SITE PLAN UPDATE

Belmont Middle and High School - Planning Board Update
May 17, 2022

PROPOSED GRADING CHANGES

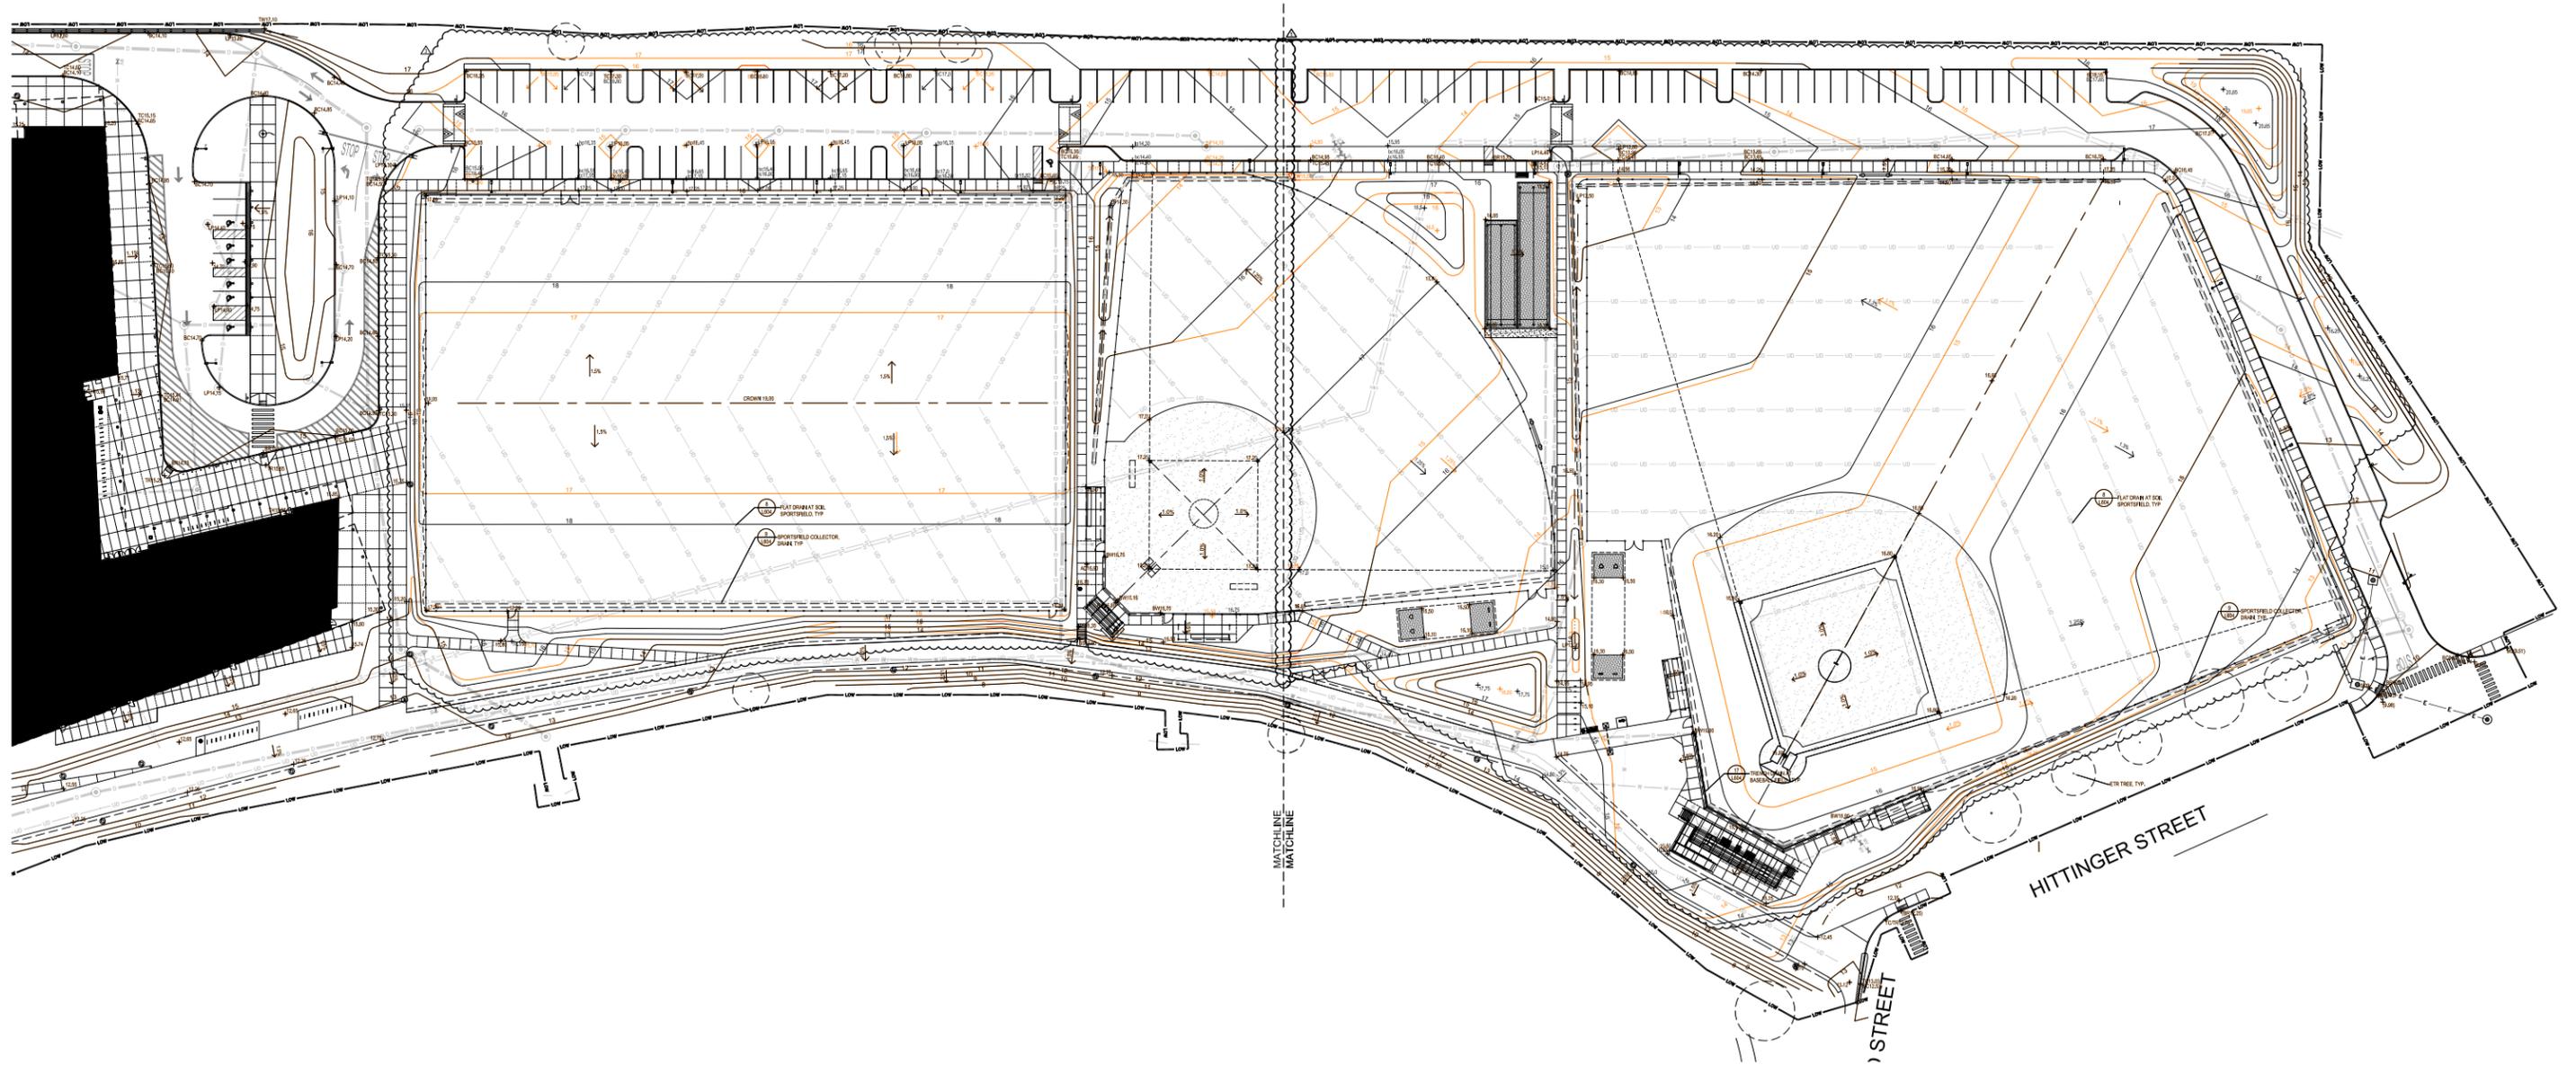
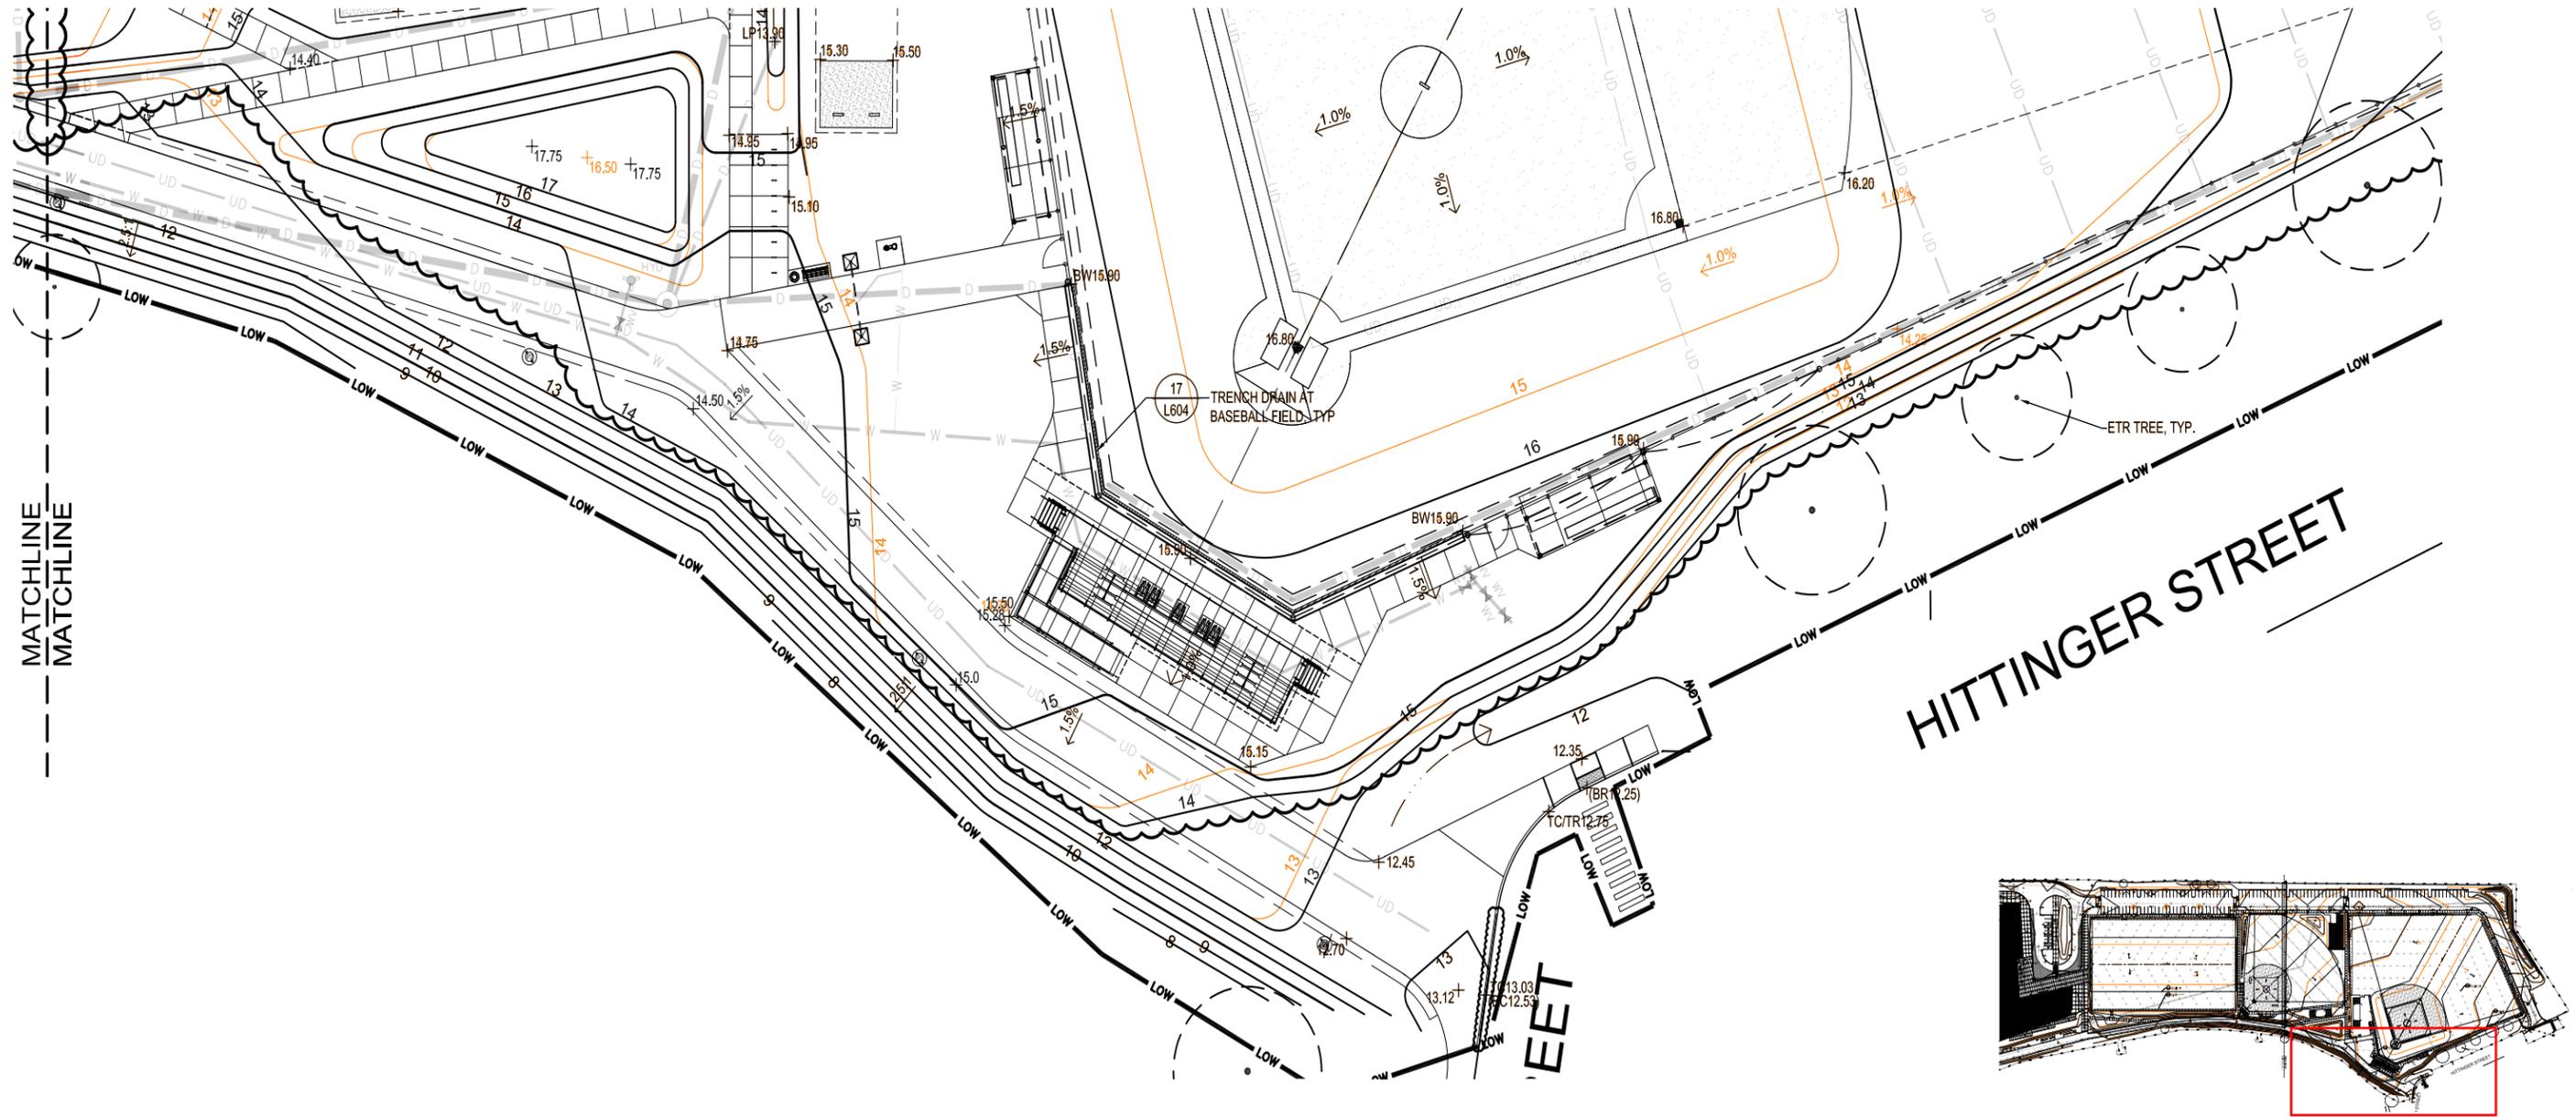
— ORIGINAL DESIGN CONTOUR
THERE IS AN AVERAGE GRADE RAISE OF APPX. 15"

— ORIGINAL DESIGN CONTOUR
— THERE IS AN AVERAGE GRADE RAISE OF APPX. 15"

PROPOSED SWING GATE CHANGES

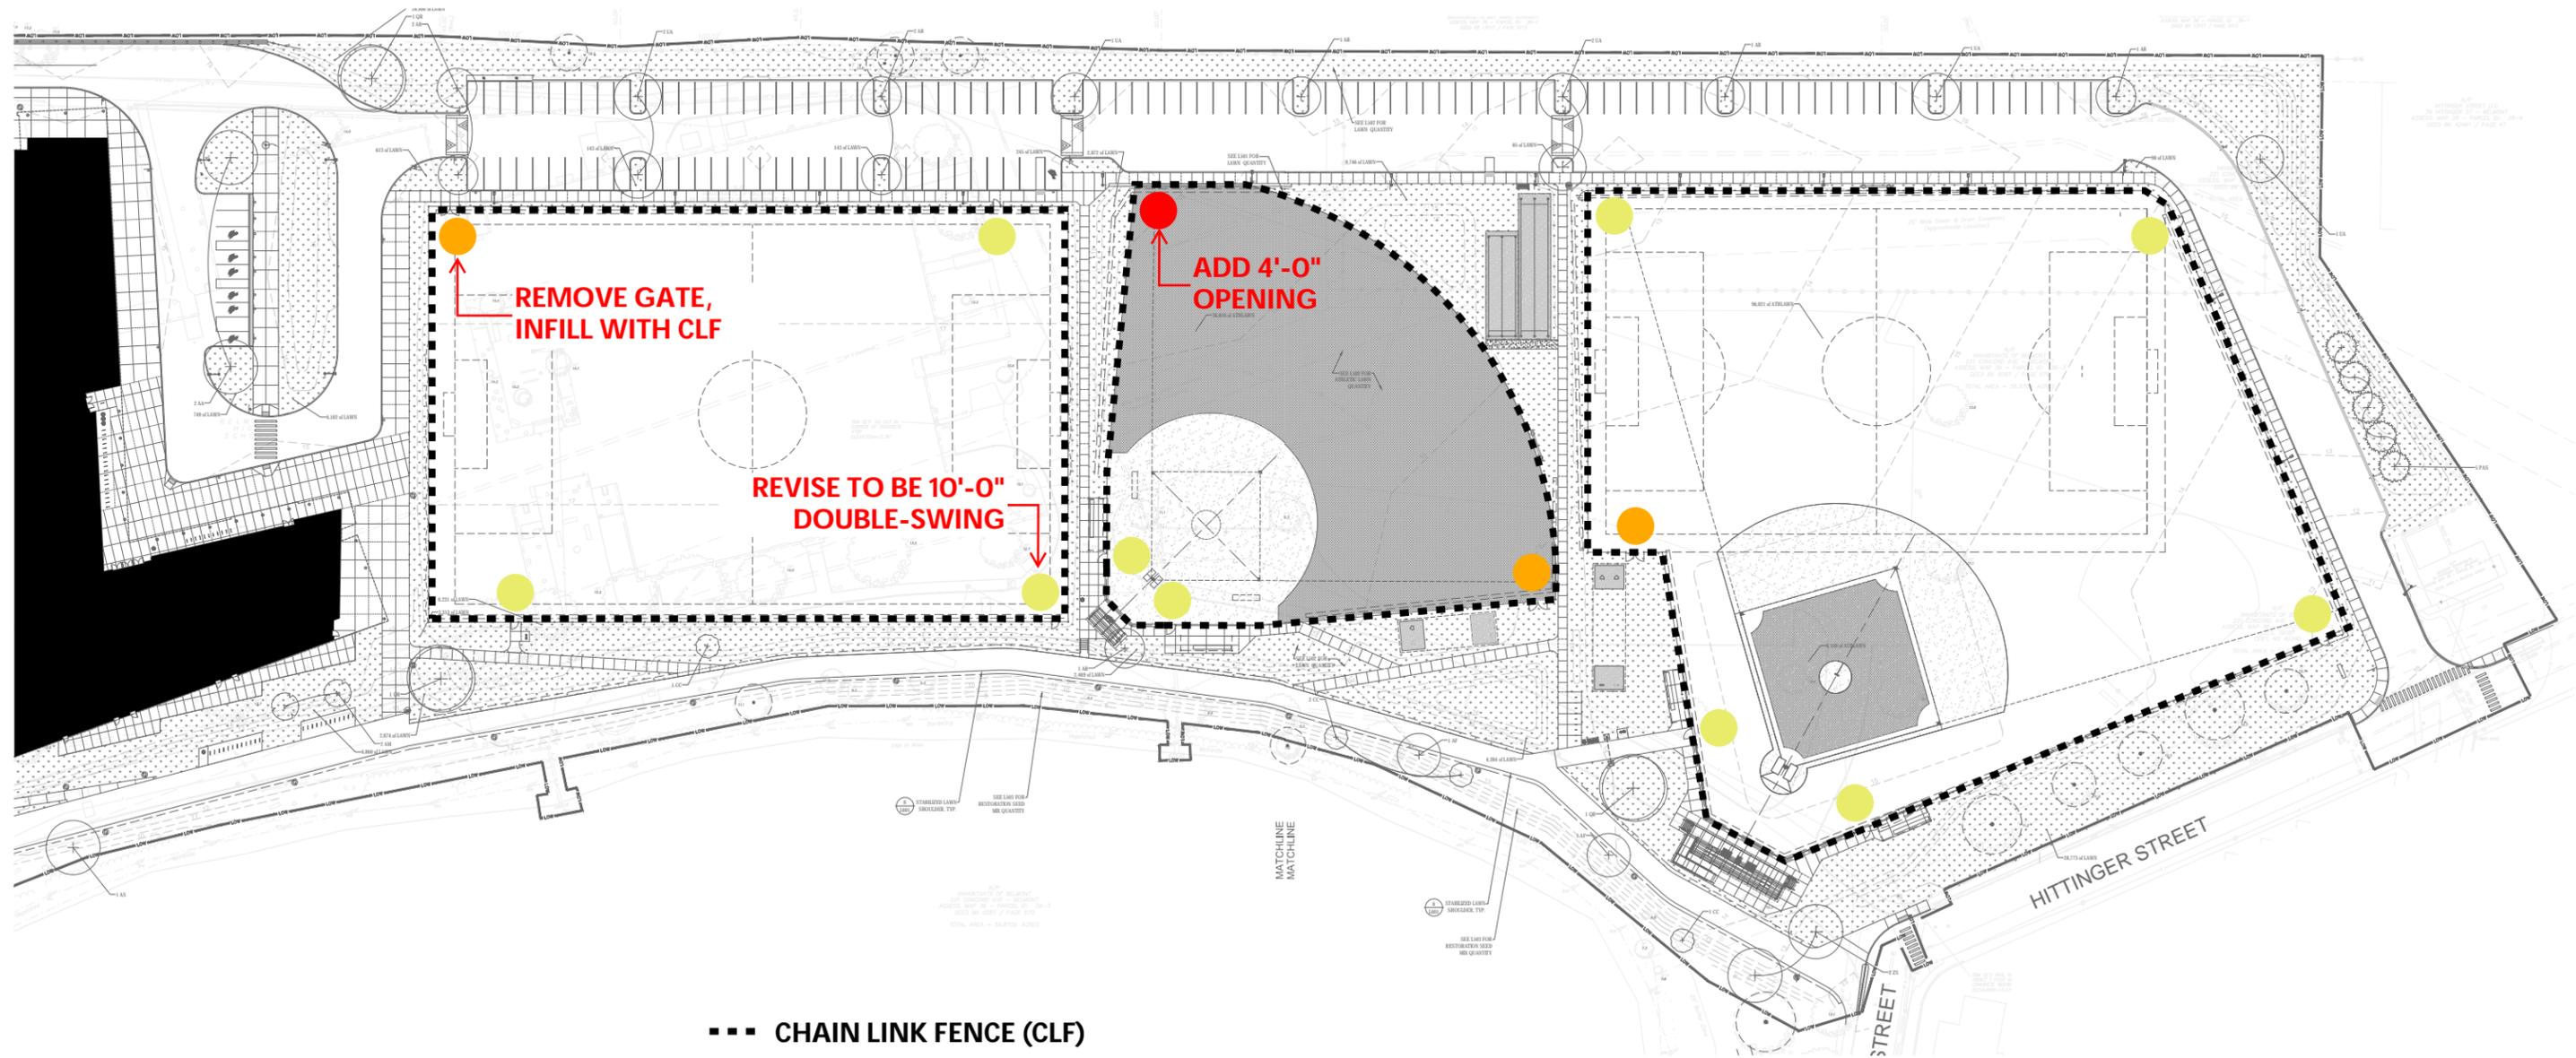
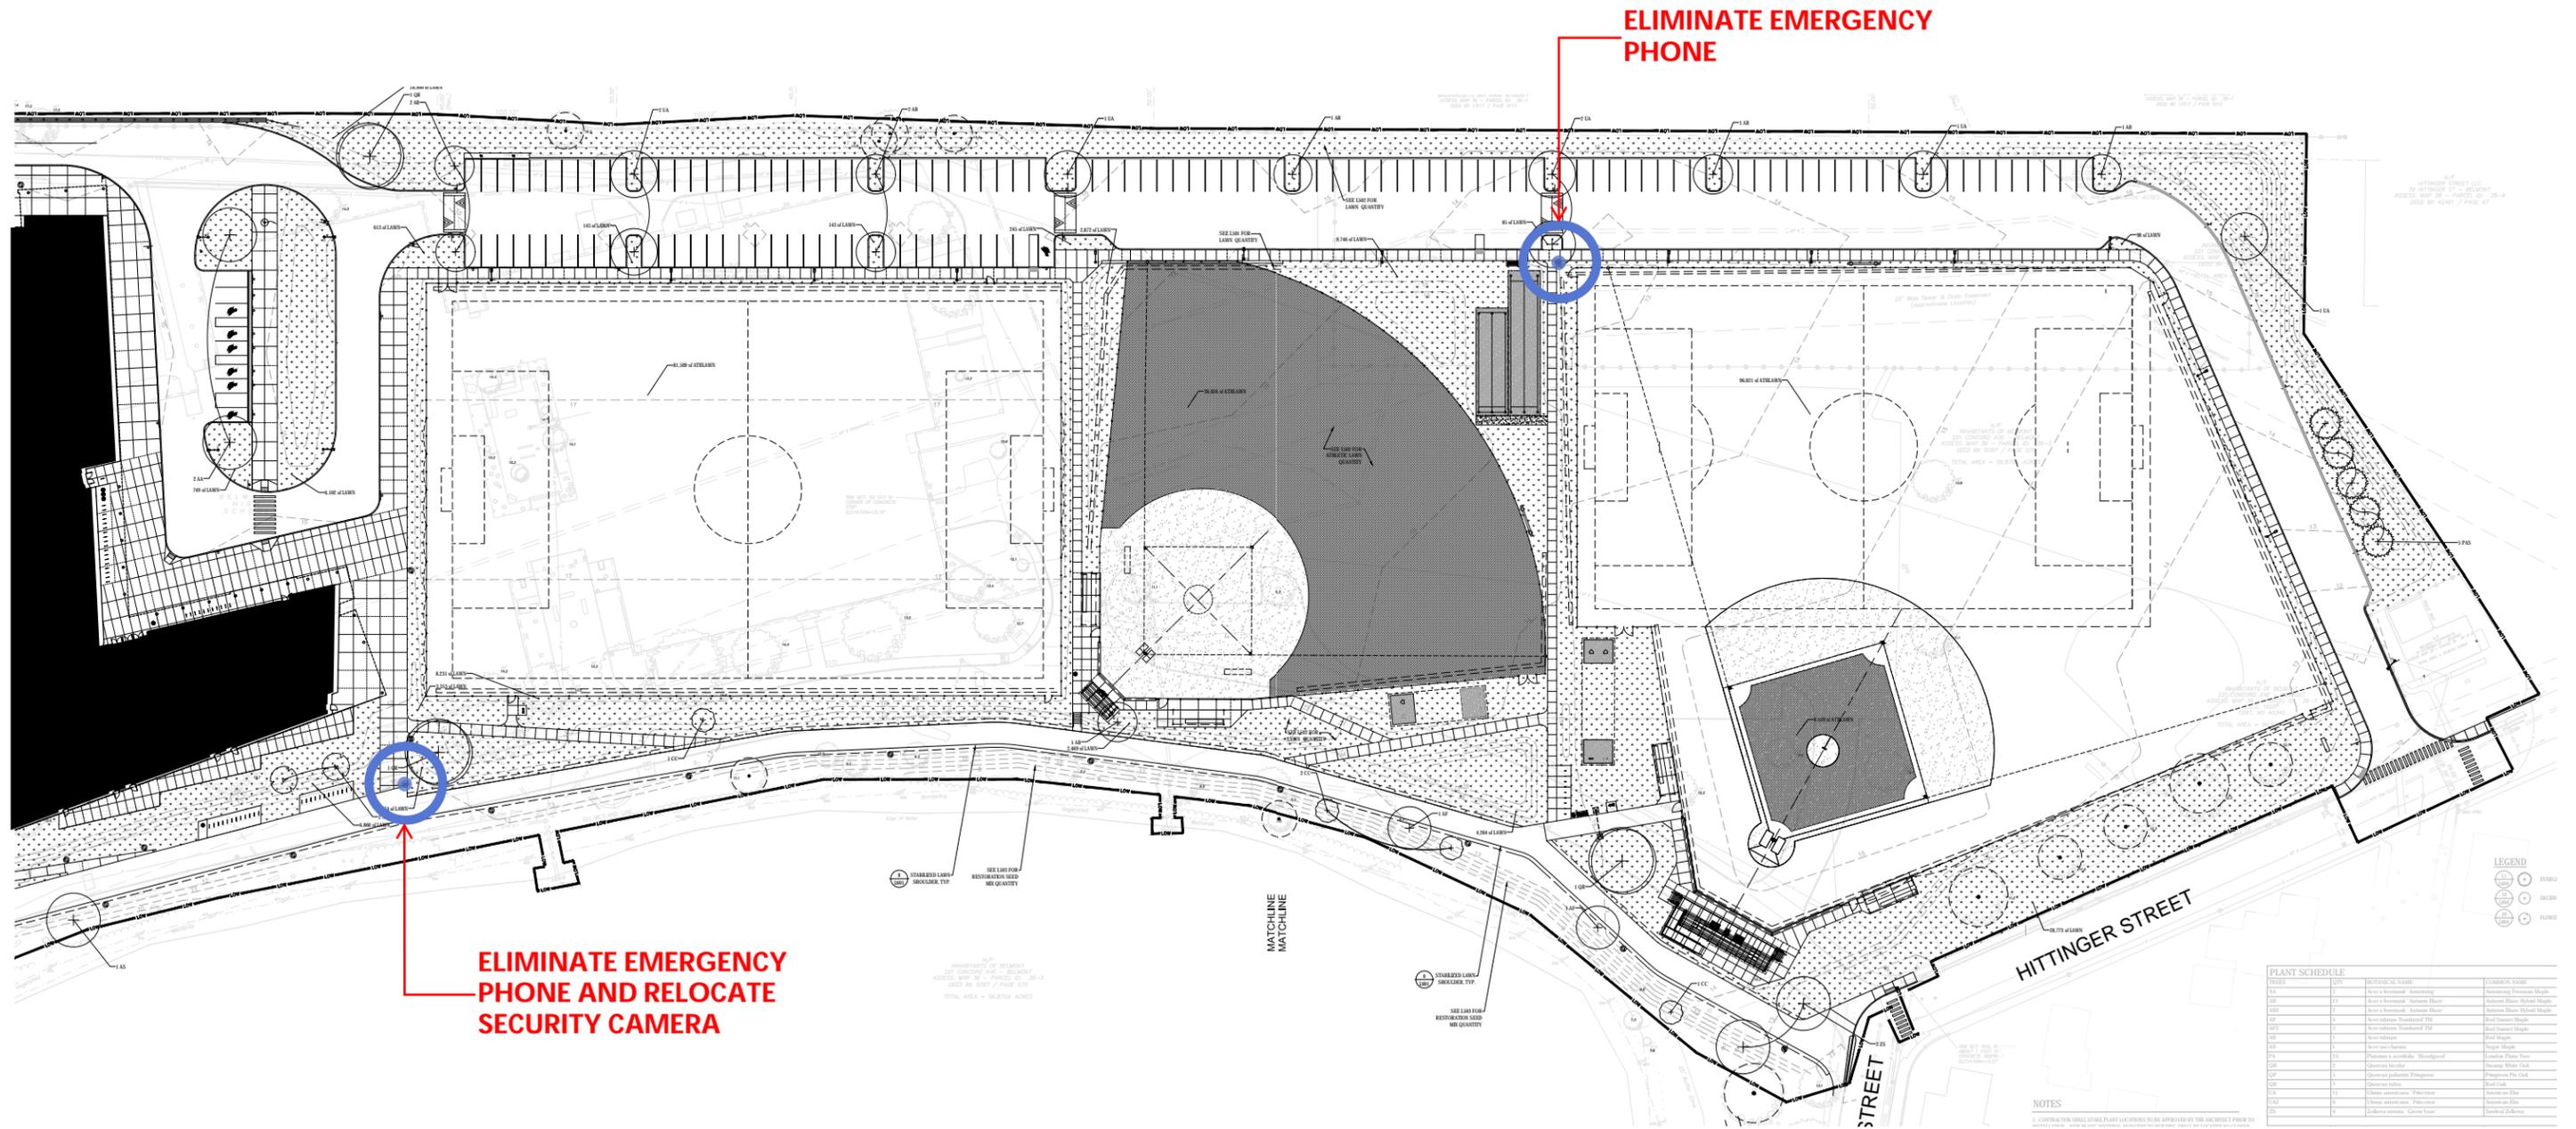
● 4'-0" SINGLE-SWING GATE (REMOVE GATE AND PROVIDE CLEAR 4'-0" OPENING, ALL LOCATIONS)
